SUBJECT: ISSUANCE OF AMENDMENTS FOR DIABLO CANYON NUCLEAR POWER PLANT,
UNIT NO. 1 (TAC NO. M95908) AND UNIT NO. 2 (TAC NO. M95909)

These amendments revise the combined Technical Specifications (TS) for the Diablo Canyon Nuclear Power Plant, Unit Nos. 1 and 2 to revise Technical Specifications 3/4.9.14.1, "Spent Fuel Assembly Storage - Spent Fuel Pool Region 2," and TS 3/4.9.14.3, "Spent Fuel Assembly Storage - Spent Fuel Pool Region 1," to allow storage of fuel assemblies in a checkerboard pattern in Region 2 of the spent fuel pool (SFP).

Amendment No. 116
License No. DPR-80

Amendment No. 114
License No. DPR-82

FIGURE 3.9-2
 MINIMUM REQUIRED ASSEMBLY DISCHARGE BURNUP
 AS A FUNCTION OF INITIAL ENRICHMENT AND PELLETT DIAMETER TO PERMIT
 STORAGE IN REGION 2

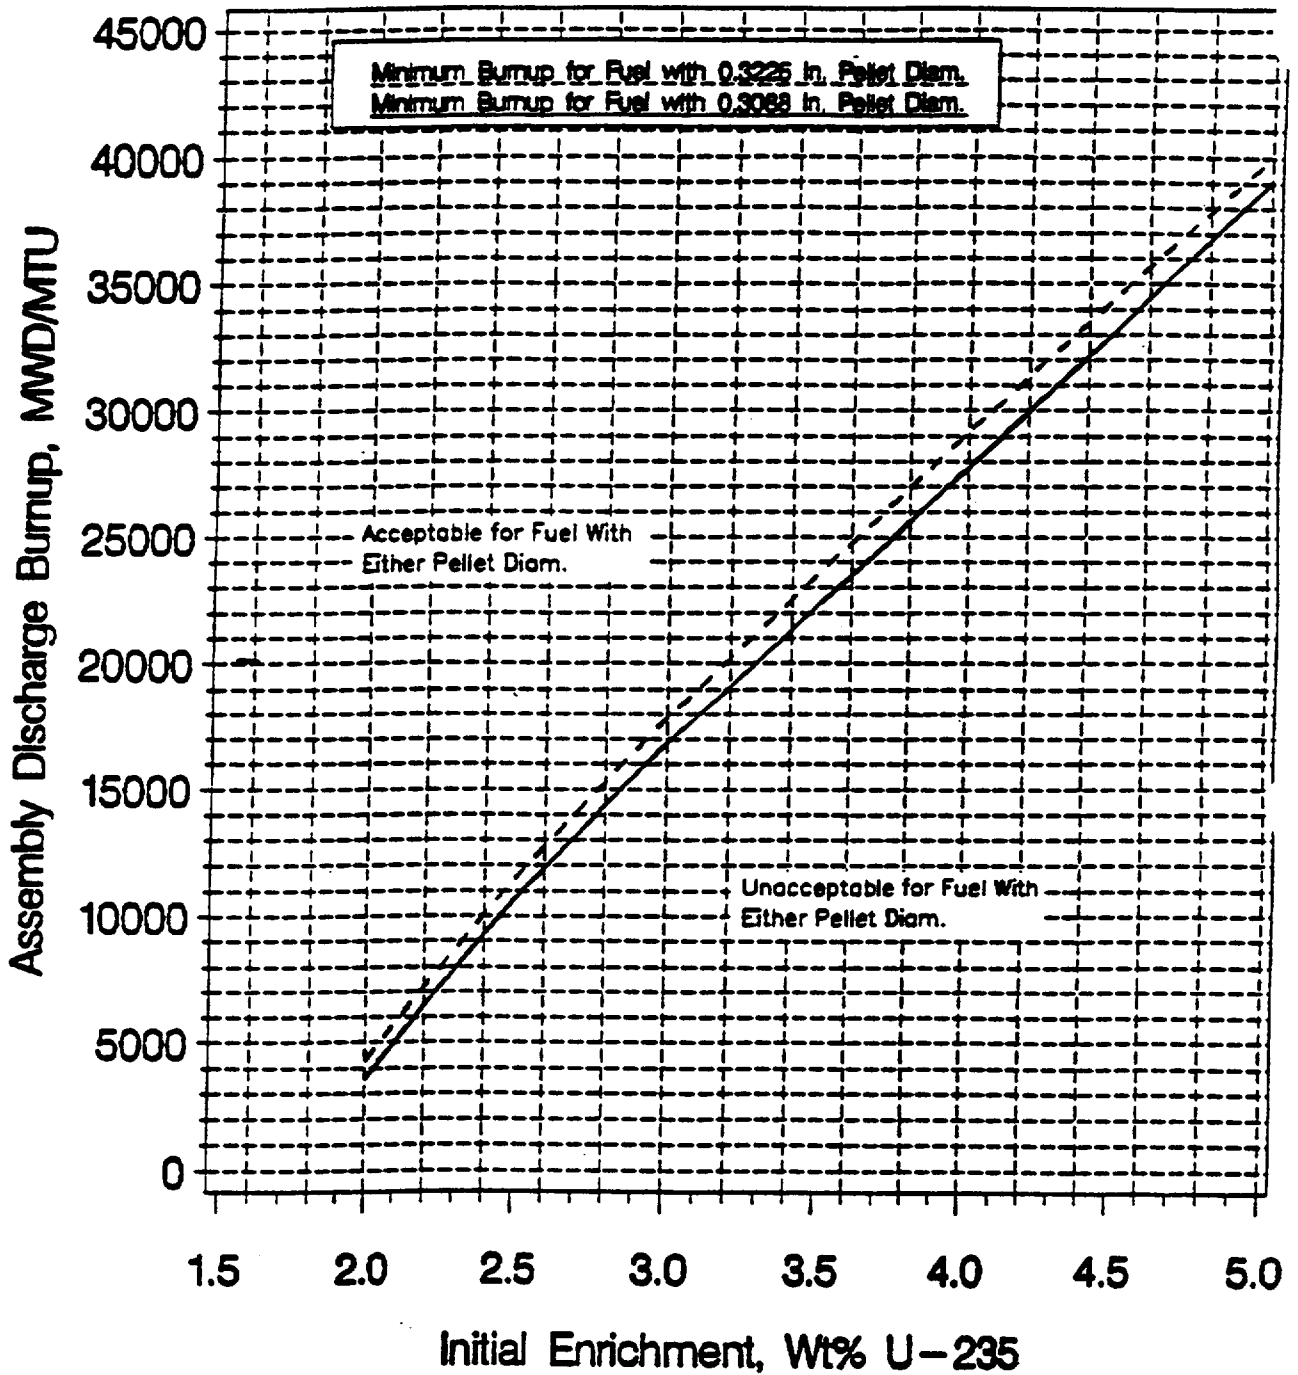
- a. The combination of initial enrichment, fuel pellet diameter, and cumulative burnup of the assemblies is within the acceptable area of Figure 3.9-2; or
- b. The assemblies are put into a checkerboard pattern with water cells or non-fissile material.
